Update Instructions

SP014/04/S

Title: Fixation of control console

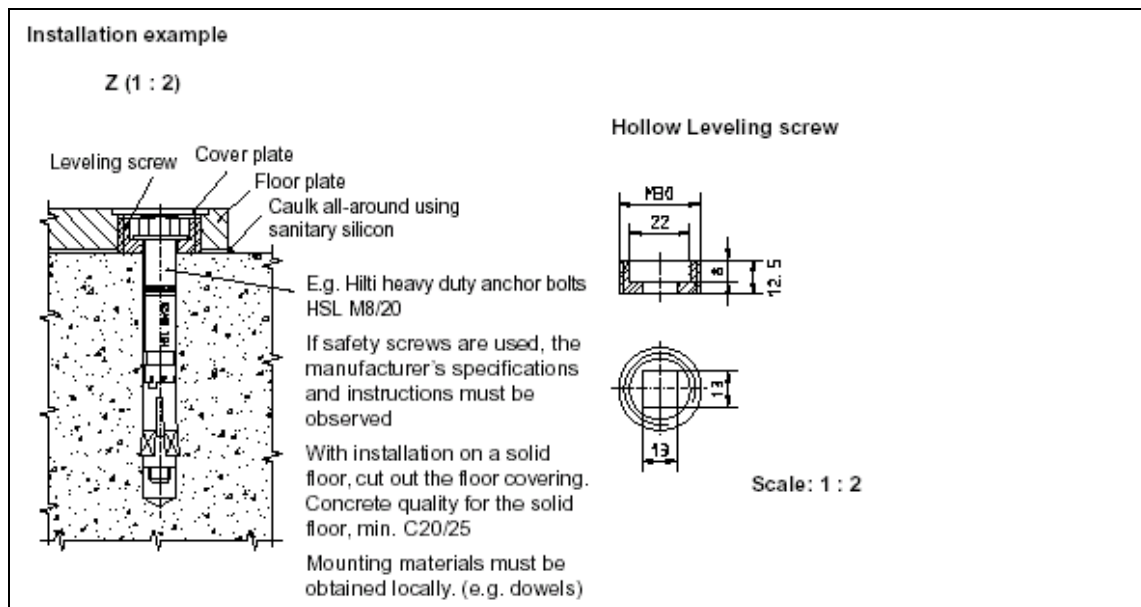
Both sales items incorporate also the material number 064 38 894, i.e. the "Console carrier kit" itself. The console carrier kit (to be assembled at site) consists of different parts, important for this UI are:

the material number 063 43 508 - Levelling screw, hollow, and

the material number 061 40 391 - Cover plate.

Two (2) of each should have been delivered to the site.

- Check whether the Radiation shield and console carrier has been installed in accordance with the corresponding description on the Page 3 - 2 of the Planning Guide.

- If yes, report this fact in manner usual for reporting about the Update Instructions, stating that the UI SP014/04/S has been complied with, (see under Final Work Steps).
- If not, proceed with correct fastening of the Radiation shield and console carrier. Level the carrier horizontally and vertically by means of the hollow levelling screws in the mounting plate and by means of the levelling bolt under the other side of the Radiation shield lead glass, apply the two dowels / anchors and tighten them. Cover the two openings by cover plates.
- Apply suitable sealant, e.g. sanitary silicone, around the mounting plate.
